Unit #100 - Septic Map

LAUREL PARK

2008 SEPTIC PLAN ADDENDUM

AS BUILT
01.13.2008
MAP 8 BLK 23 LOT 100
SCALE: 1"=30'

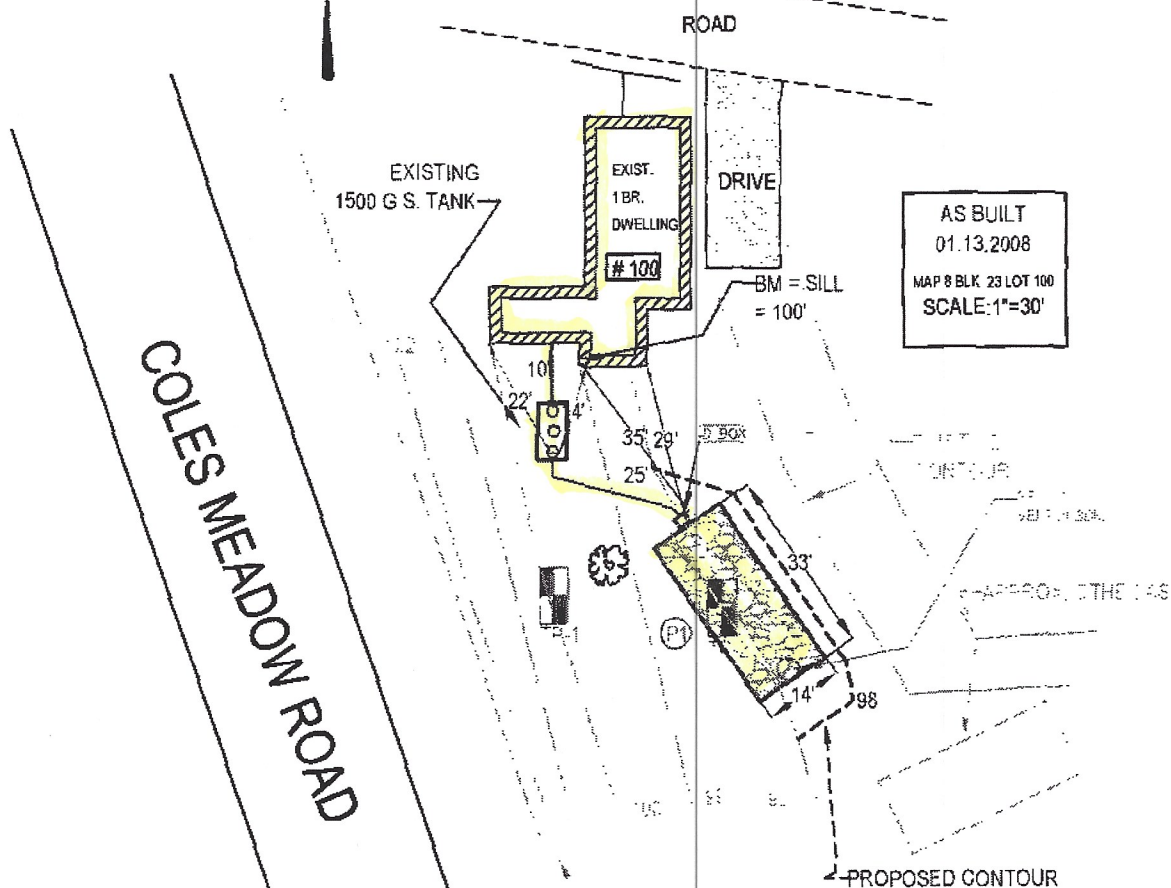
DUE TO LATE REGULATION CHANGES 4-22-2006

ALL NEW SYSTEMS MUST:

- 1.) INSTALL PVC RISERS OVER D. BOX'S BURIED DEEPER THAN 9" AN PLACE IRON REBAR ON TOP.
 - 2.) HAVE 4" PERFORATED, PVC INSPECTION PORTALS TO BOTTOM OF STONE BED, WITH SCREW RISER TO 3" OF SURFACE, MARKED WITH REBAR. *All OPENINGS & COMPONENTS marked with magnetic tape*
 - 3.) HAVE PERFORATIONS IN BED AT 4 AND 8 O-CLOCK POSITIONS.
- NOTE: THESE ARE NEW STATE REGULATION REQUIREMENTS (4-22-06), NOT NECESSARILY THE OPINION OF THE DESIGNER.
